**From:** Andrew Leon  
**Sent:** Tuesday, February 21, 2023 8:25 AM  
**To:** Ryan Harriman  
**Subject:** FW: Totally Against DSR22-014 Baskin Robbins Proposed 10-unit building

**From:** Sarah Fletcher <[fletchsa1@gmail.com](mailto:fletchsa1@gmail.com)>  
**Sent:** Sunday, February 19, 2023 7:04 PM  
**To:** Andrew Leon <[andrew.leon@mercerisland.gov](mailto:andrew.leon@mercerisland.gov)>; Jeff Thomas <[jeff.thomas@mercerisland.gov](mailto:jeff.thomas@mercerisland.gov)>; Planning Commission <[Planning.Commission@mercergov.org](mailto:Planning.Commission@mercergov.org)>; Design Commission <[Design.Commission@mercergov.org](mailto:Design.Commission@mercergov.org)>  
**Subject:** Totally Against DSR22-014 Baskin Robbins Proposed 10-unit building

**Landscaping**

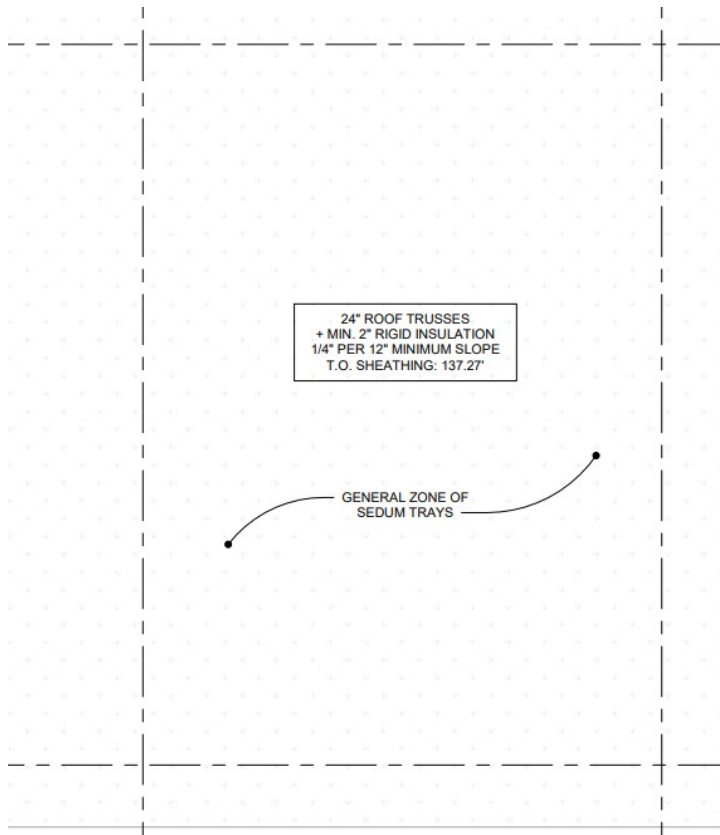
It says that 3,250 sf of sedum trays on the roof, but if you look at the plans on page 7, it does not show 3,250 sf of sedum trays, it shows a portion. And are you trying to say, that they can go across the road, buy a few trays of sedum and put them on the roof, and that is sufficient?

As I am a layman and don't know how to read plans, how much exactly is it showing? I

- a) And what happens if the greenery dies?
- b) That would mean that they are below their landscaping requirement, what happens if they fall below the required landscaping requirement?
- b) Is someone going to be watering the sedum?

If you look at the plans, it has a section of the roof as for the sedum trays on a portion and not even on the whole roof, I doubt very much it equals 3,250 sf of roof space?

Is the roof going to be sloped or flat? It is hard to tell.
